ADDENDUM NO. 3

Warren Central High School Phase 3 Renovation and Addition 9500 E. 16th Street Indianapolis, IN 46229

This Addendum forms a part of and modifies the Bidding Requirements, Contract Forms, Contract Conditions, the Specifications and the Drawings dated January 3, 2023, by CSO Architects. Acknowledge receipt of the Addendum in the space provided on the Bid Form. Failure to do so may subject the Bidder to disqualification.

DRAWING NUMBER A504

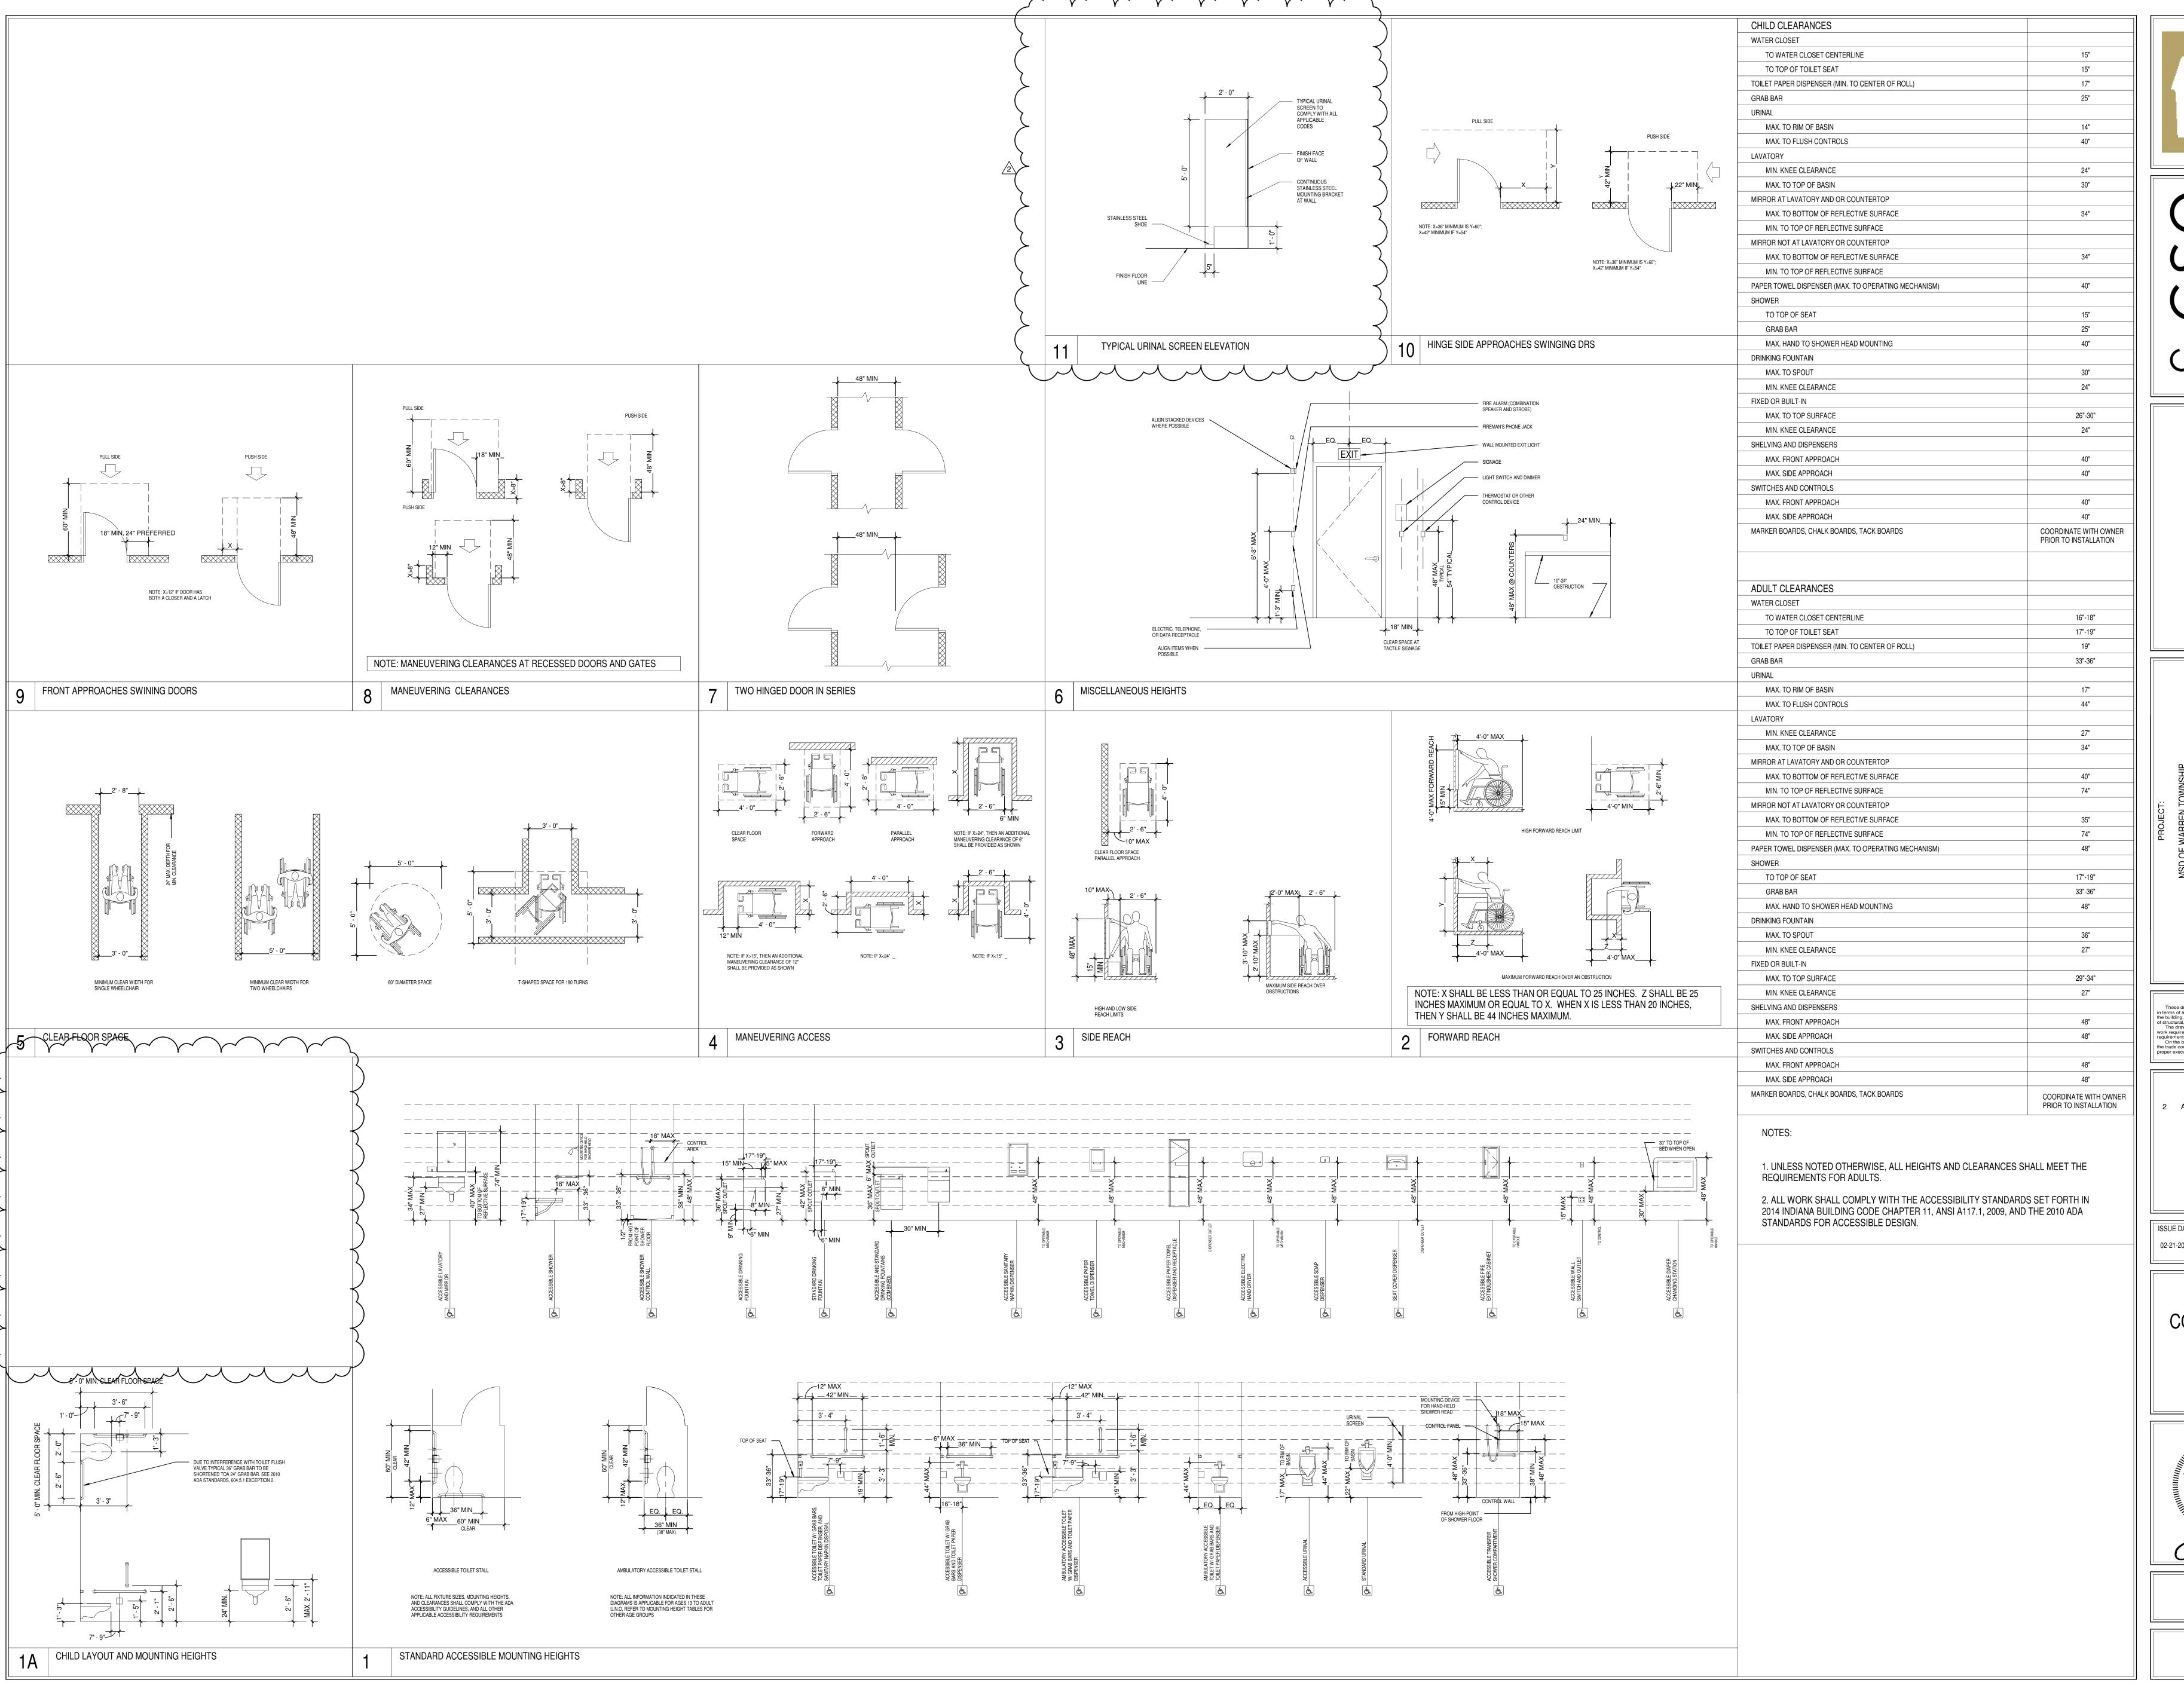
A. ADD Window elevation W18 as indicated on attached, re-issued Sheet A504.

A801N

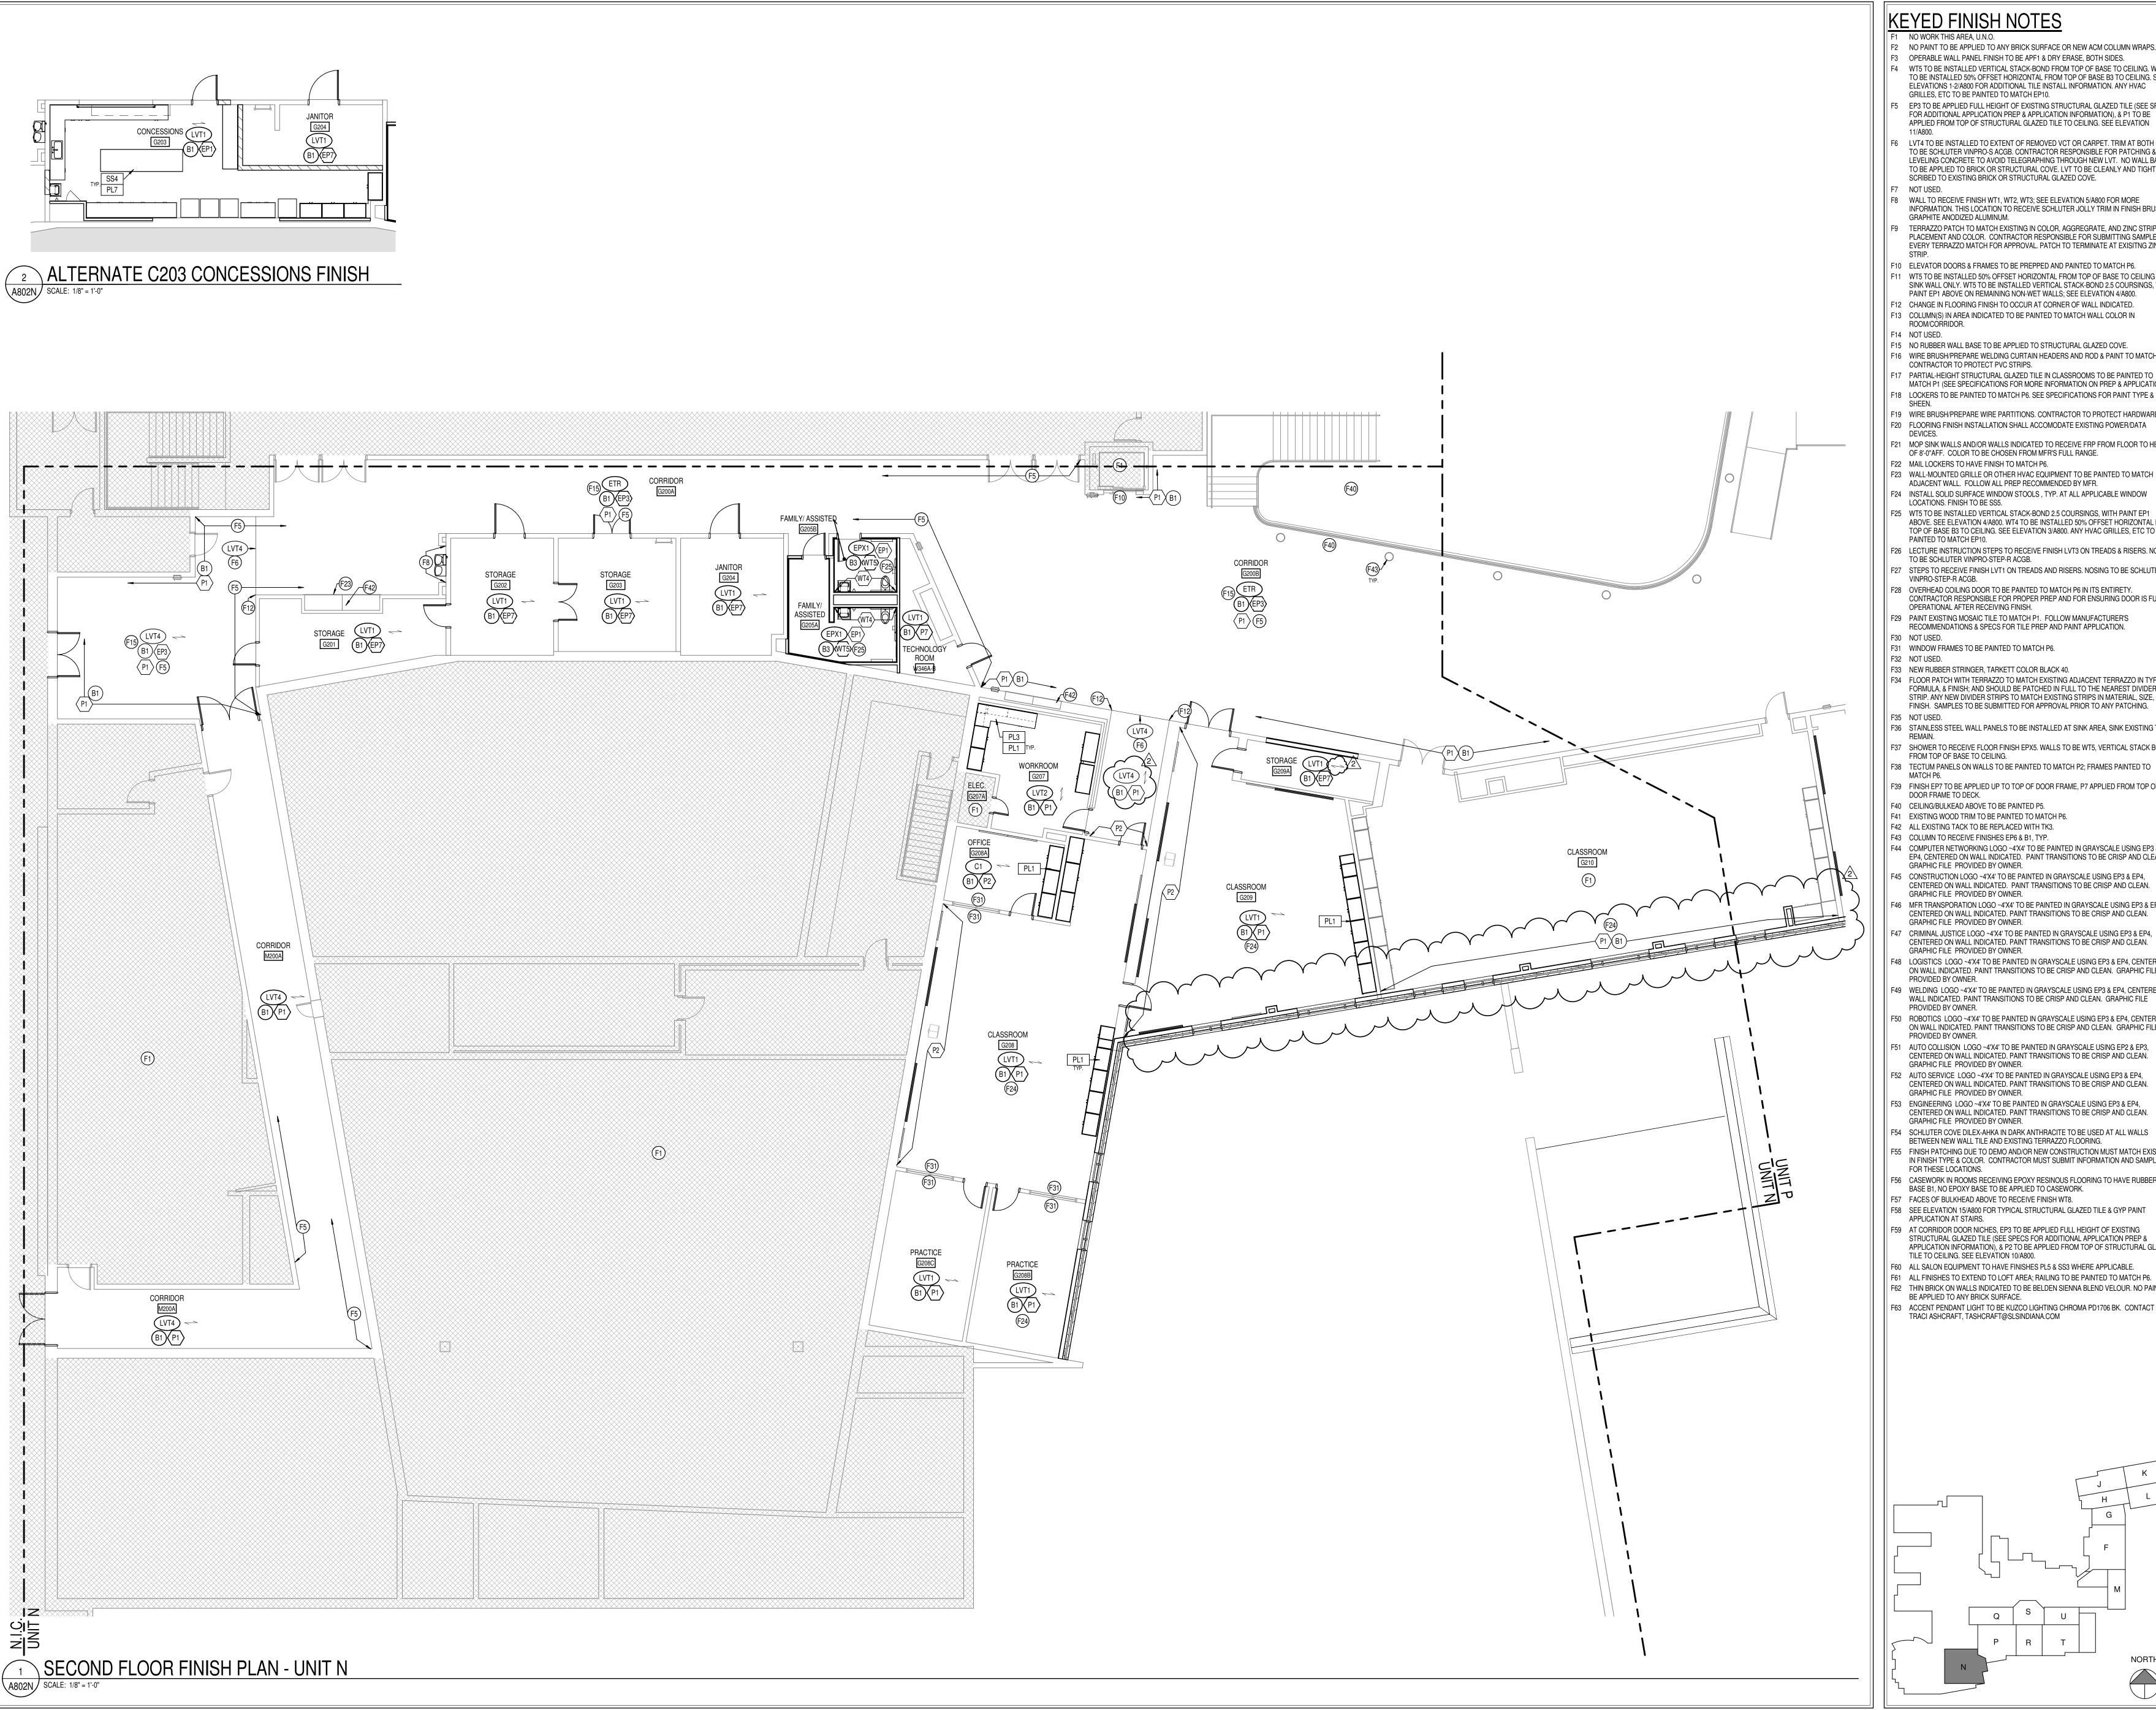
- A. At Kitchen G101G, counter marked "SSX" shall be CHANGED to "SS4" as indicated on attached, reissued Sheet A801N.
- B. At Kitchen G101G, the casework shall be tagged "PL1", and the countertops at the north and east walls shall be marked "PL3" as indicated on attached Sheet.

A802N

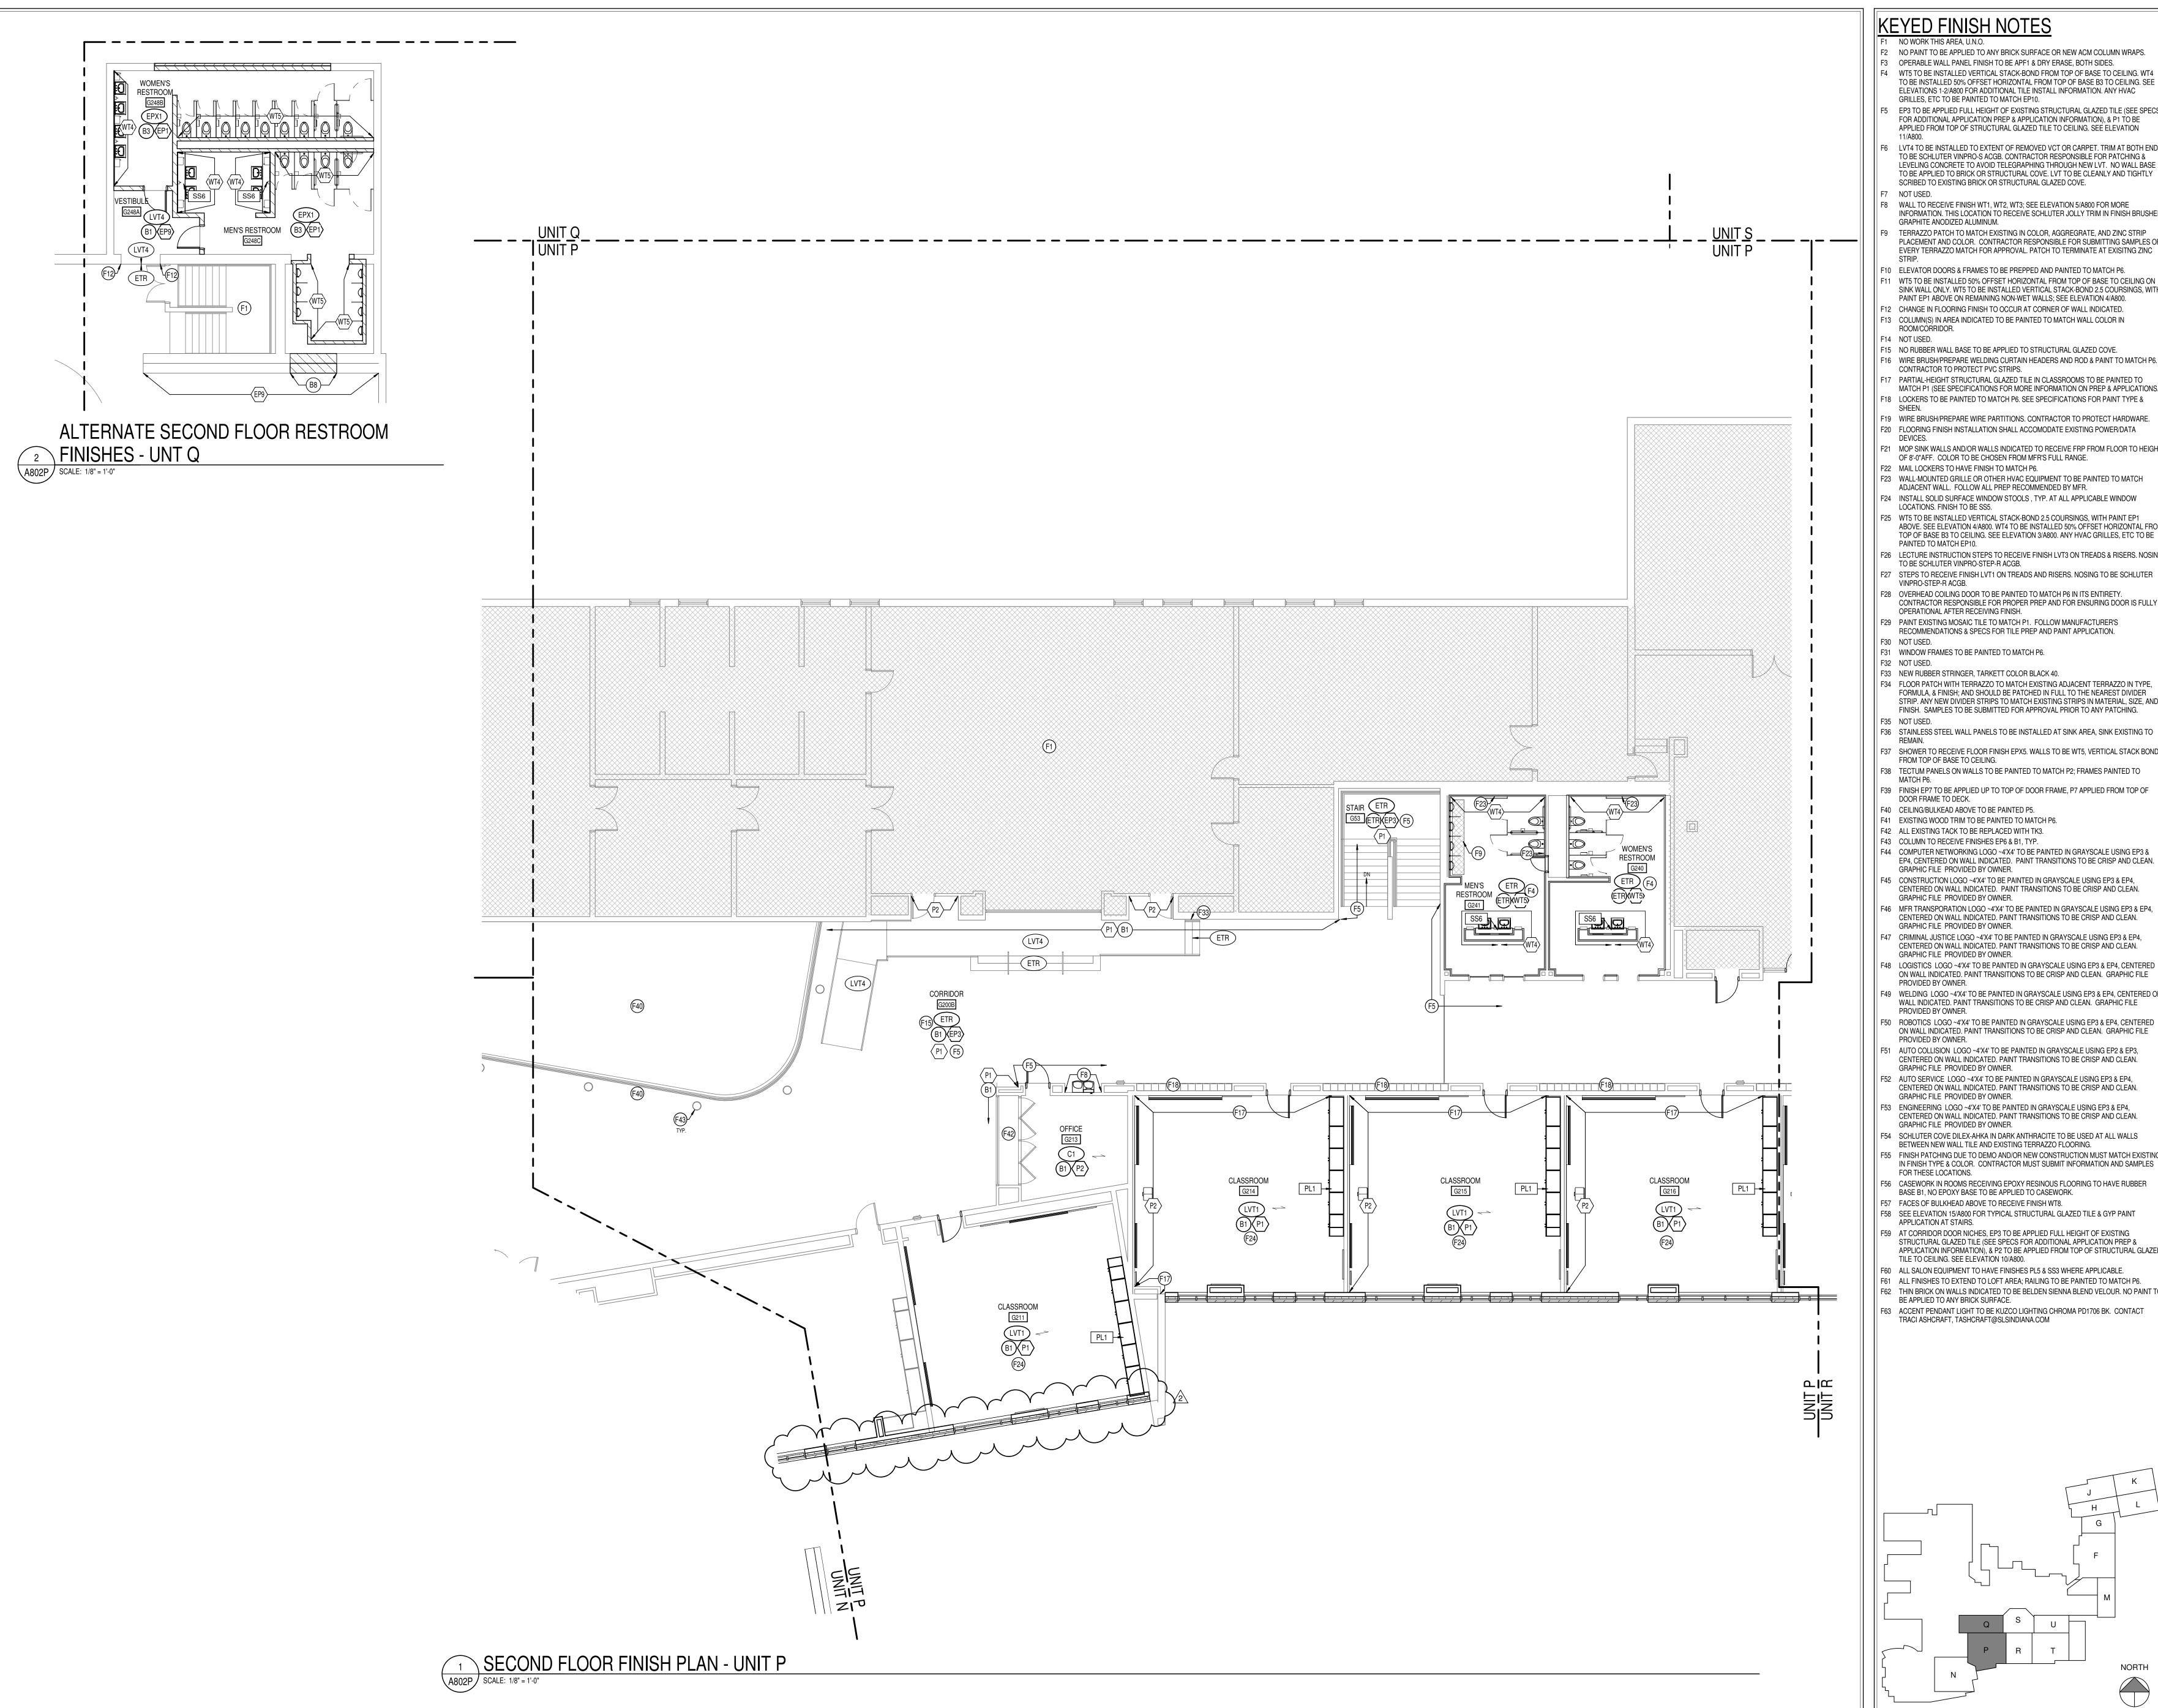
- A. Exterior walls of G209 & G210 clouded as shown for architectural window changes
- B. Finishes ADDED for clarification at hall outside G208, as shown on sheet.
- C. Flooring finish direction arrow ADDED to G209A, as shown on sheet
